STATE OF MAINE
 DEPARTMENT OF TRANSPORTATION
 16 STATE HOUSE STATION
 AUGUSTA, MAINE
 04333-0016

October 8, 2009
 Subject: **Trenton, Acadia Welcome
 Center**
 Federal Project No. 16123.50
 State Pin No.016123.50
Amendment No. 1

Make the following changes to the Bid Documents:

SHEET NUMBER
C-63
 OF 63

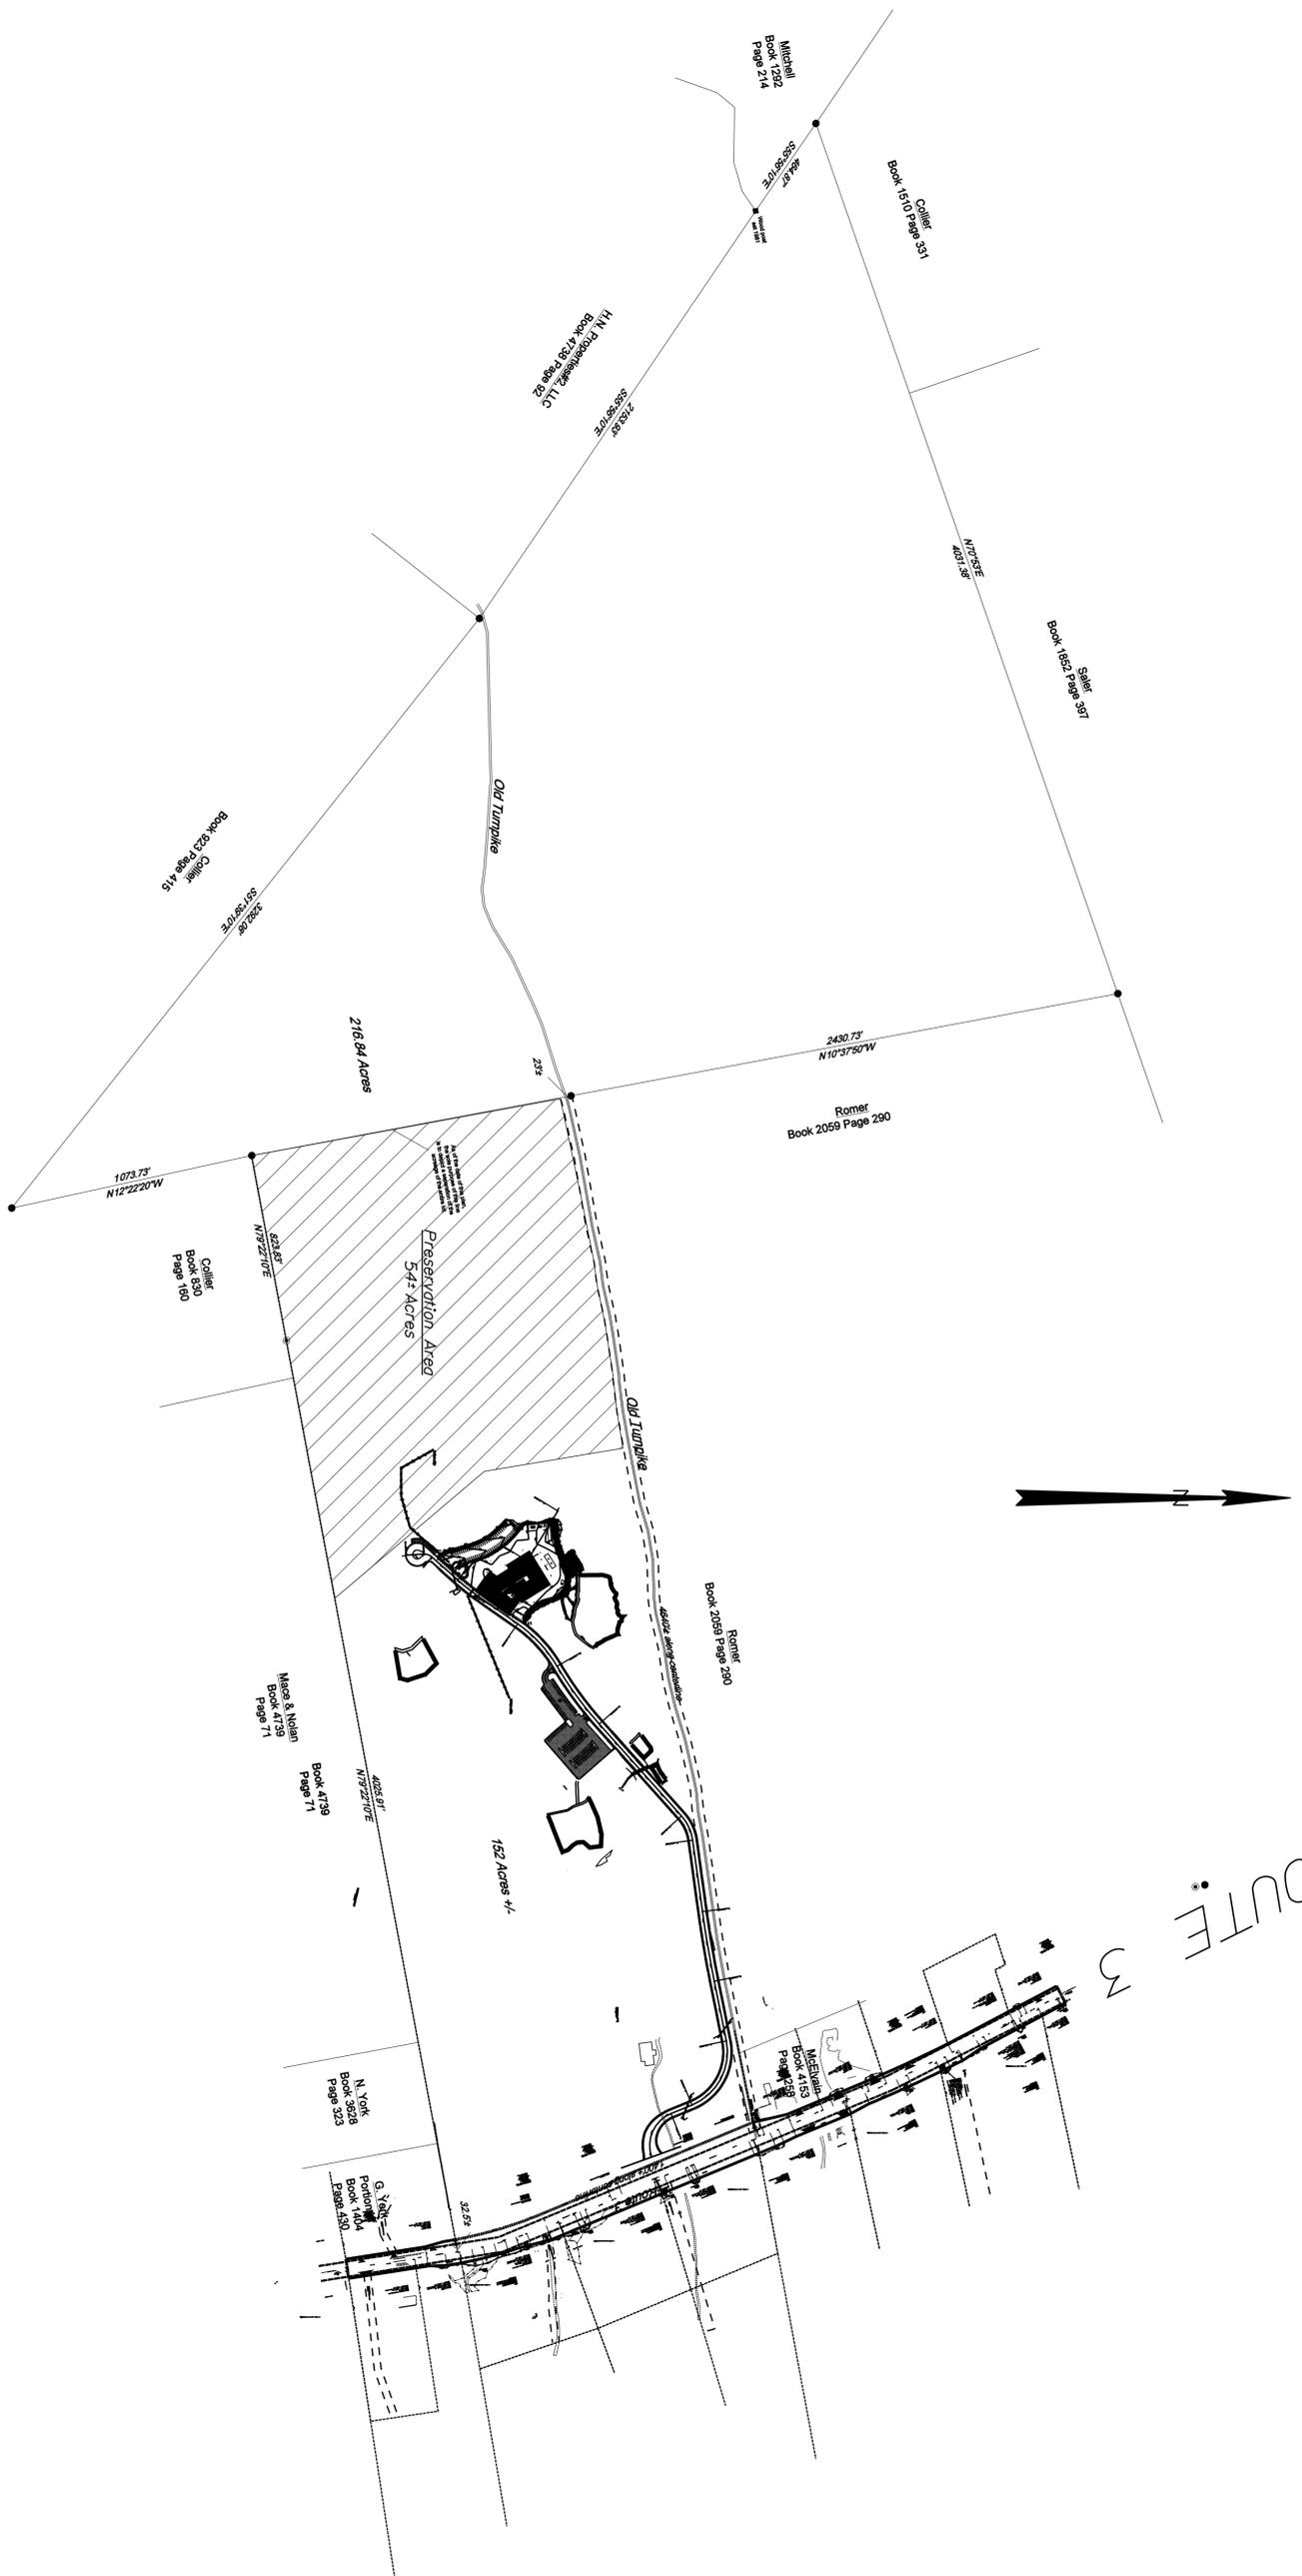
3. ADD Sheet C-63 Boundary Plan in its entirety.
4. SHEET C-102 – Utility Plan, DELETE the Electric (E) and Water (W) lines which are designated “Option 1”.

E1 UNDERGROUND PIPING DETAIL
NO SCALE FOR REFERENCE ONLY

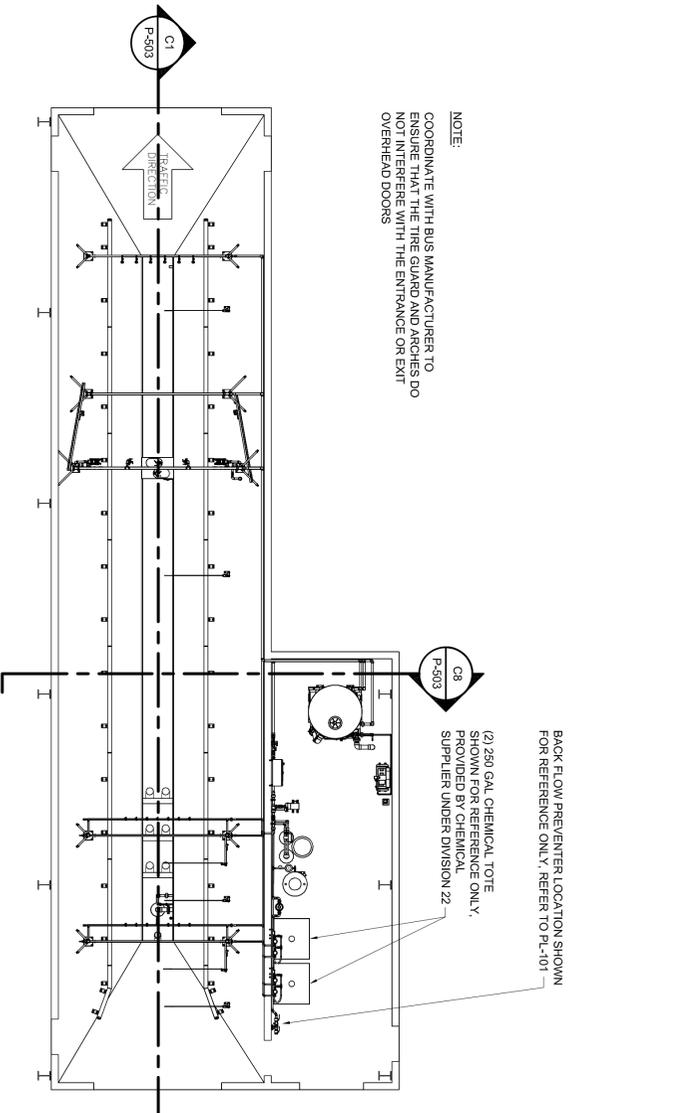
7. DRAWING P-500 – Detail E1, ADD boiler water make-up feed line as indicated on SKP-1, attached.
8. DRAWING P-501 – Detail A1, at the piping blow up part plan DELETE the following note: “2” PVC80 Pipe from City Water Inlet to Eq-Module Circulation Pump Discharge Line For Pit Fill Pipe Line”. ADD in its place: “2” PVC80 NPC to Eq-Module Circulation Pump Discharge Line For Pit Fill Pipe Line”.

MAINE DEPARTMENT OF TRANSPORTATION
ACADIA GATEWAY FACILITY
BUS MAINTENANCE FACILITY
BUS WASH PLUMBING
COORDINATION DETAILS

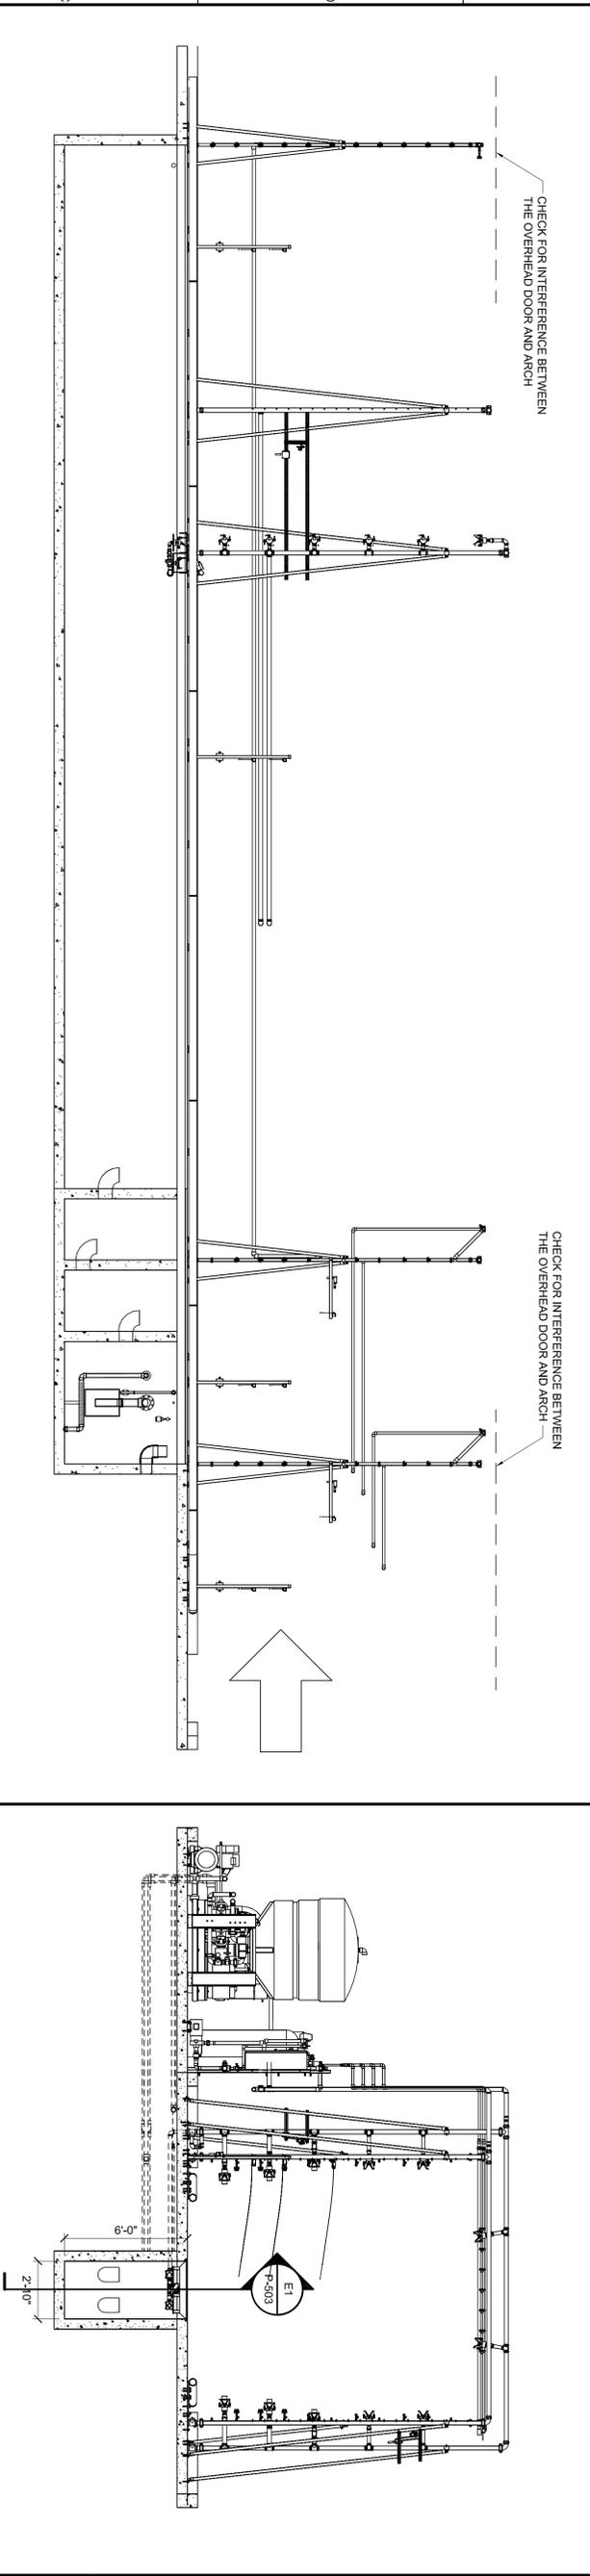
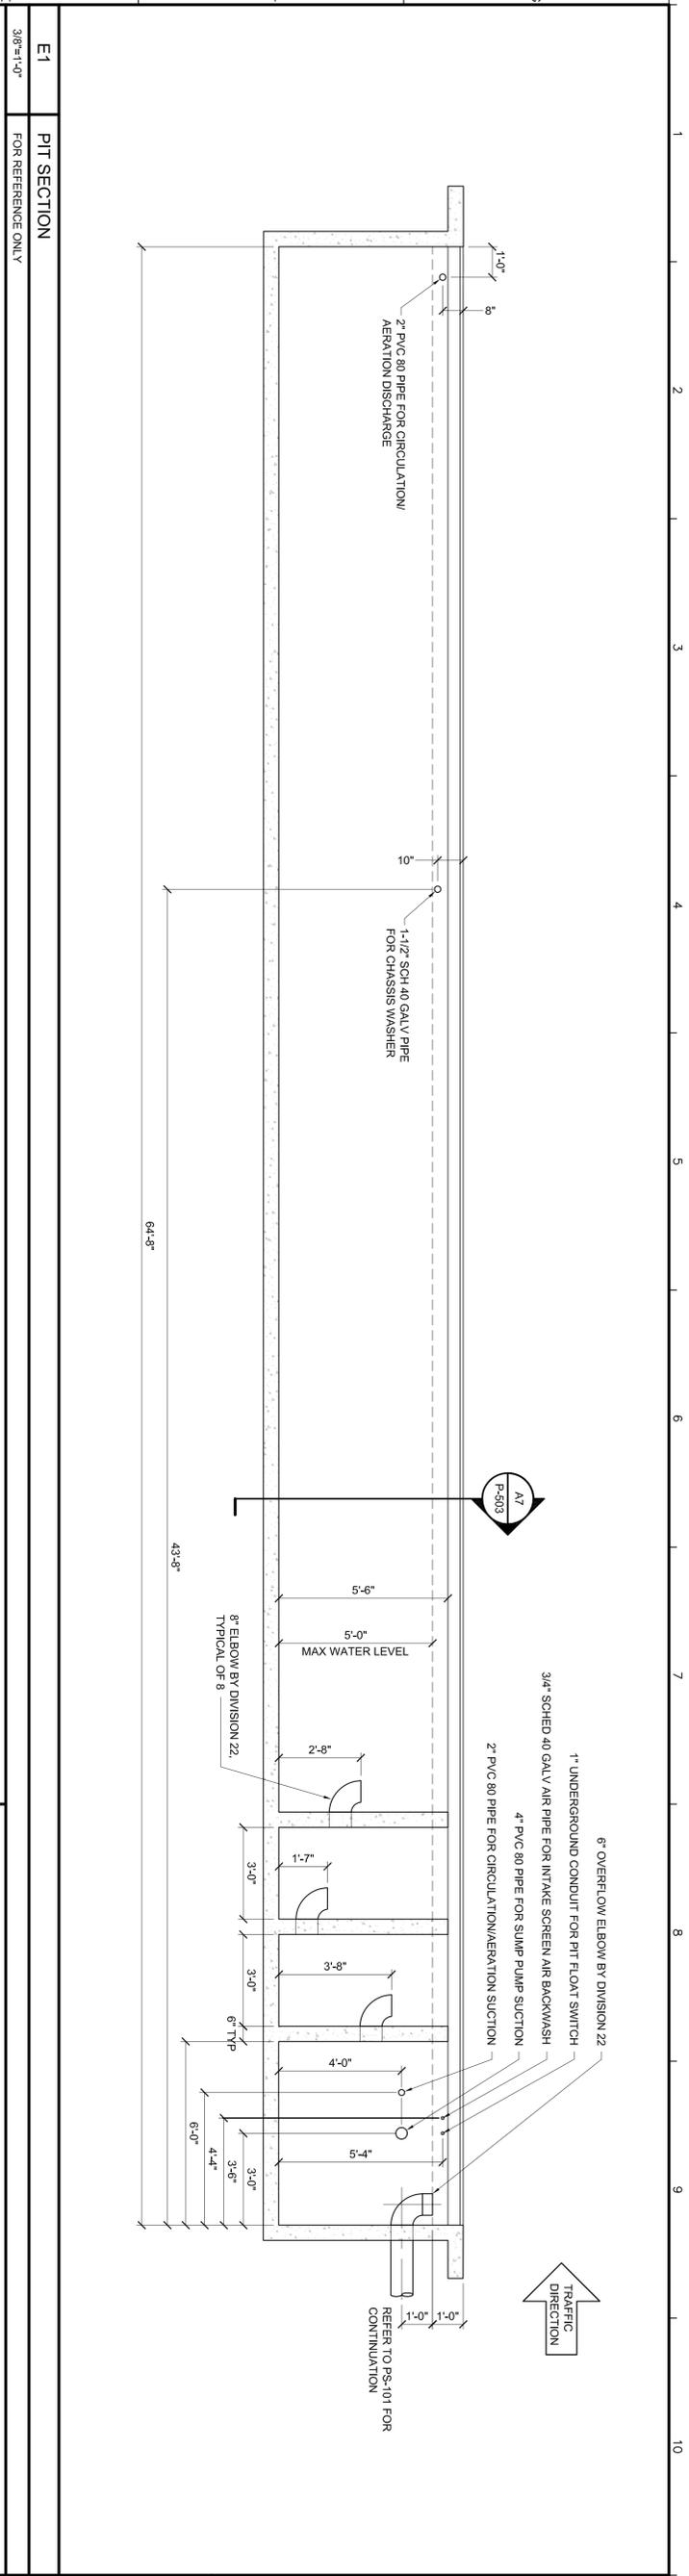
9. DRAWING P-501 – Detail A1, at the water softener area DELETE the following note: “2” Copper Pipe from City Water to Booster Pump Suction”. ADD in its place: “2” Copper NPC to Booster Pump Suction”.

BUS WASH PLUMBING SCHEMATIC

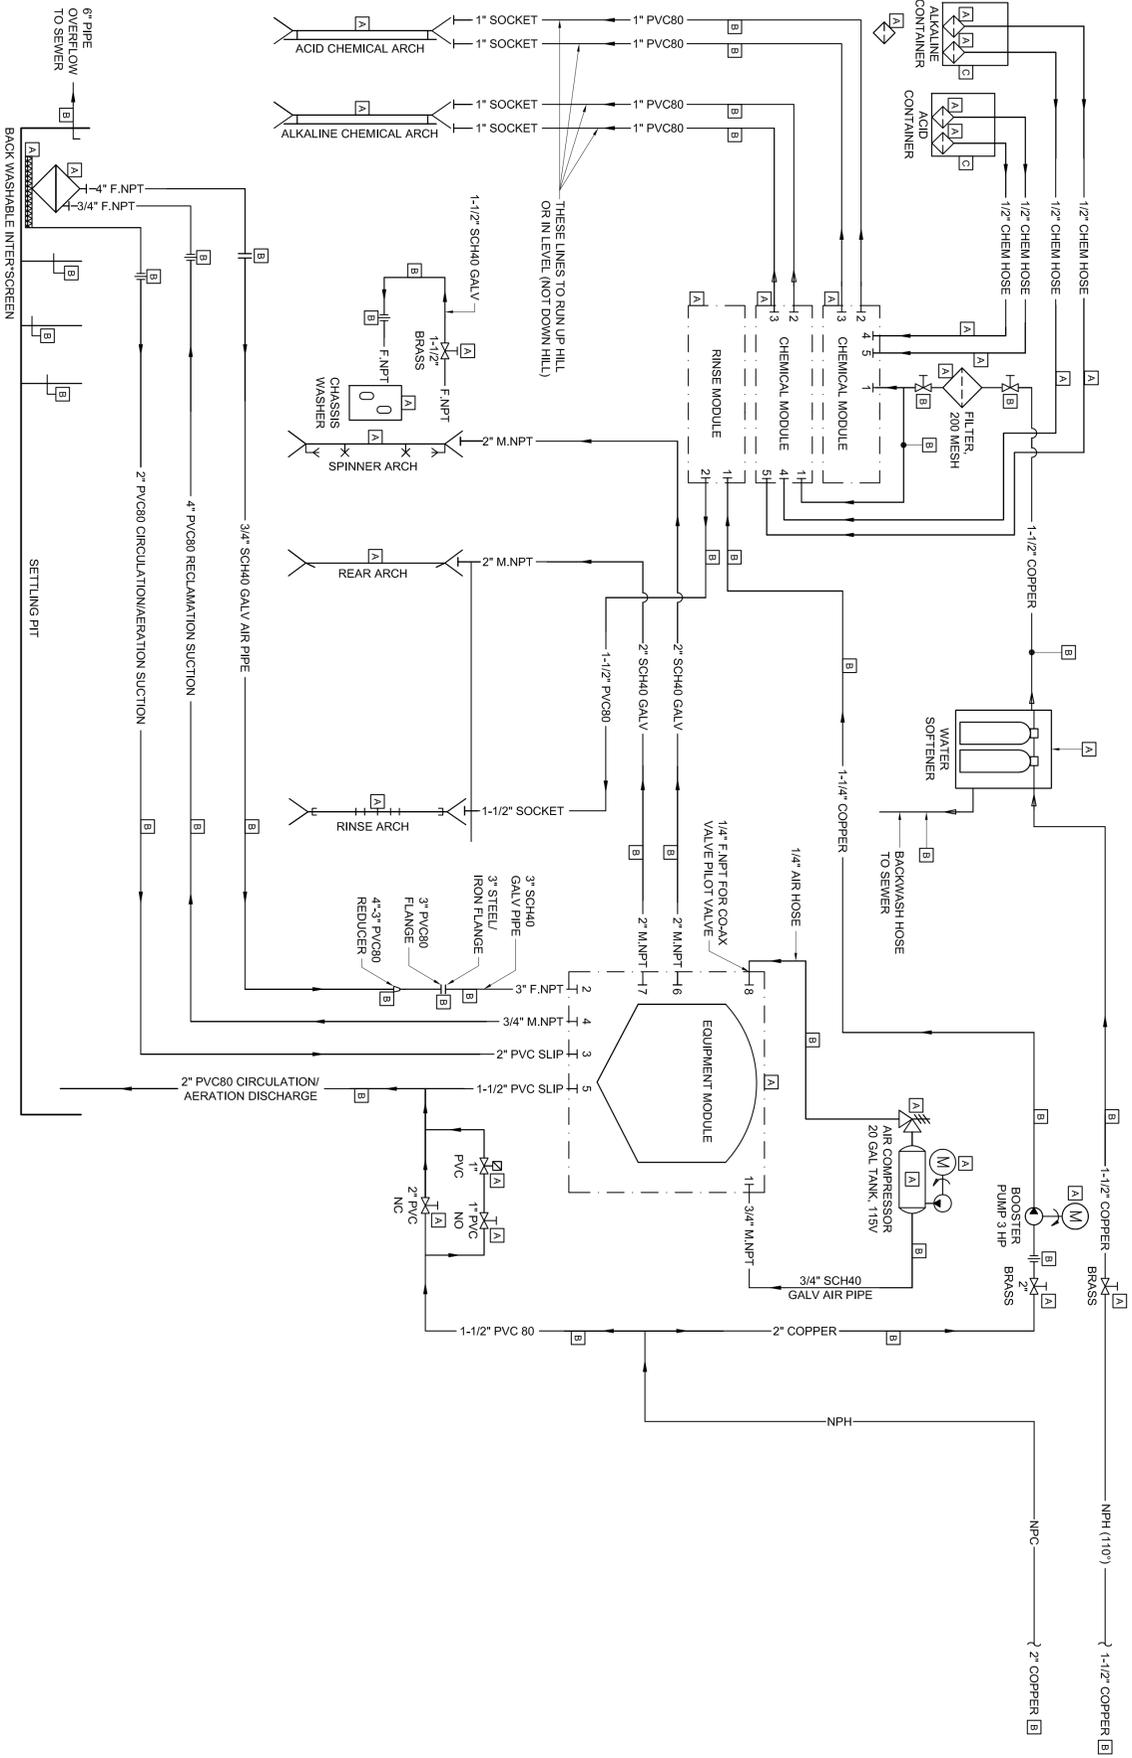
10. DRAWING P-503- Schematic A1, At the water softener, DELETE the following note: “Backwash Hose to Sewer”. ADD in its place: “Backwash Hose to Wash Recycle Room Floor Drain.”
11. DRAWING P-600 – Detail A1, ADD size and model reference to the thermostatic mixing valves as indicated on SKP-2, attached.
12. DRAWING ES-100 - DELETE detail marker D3/ES-500 at the underground electrical between the Bus Maintenance Facility and the Fueling Station. ADD in its place a detail marker D2/ES-500.
13. DRAWING ES-500 - At Detail F8, DELETE two 5” conduits for secondary electric service. ADD in their places two 4” conduits for secondary electric service.
14. DRAWING EP-101 – Refer to attached sketch SKE-01 for receptacles and wiring for lifts to be provided under Option #5.
15. DRAWING EP-400 - At Feeder Schedule, DELETE conduit description for Feeder Tag 9. ADD in its place: IN EACH OF (2) 4”.
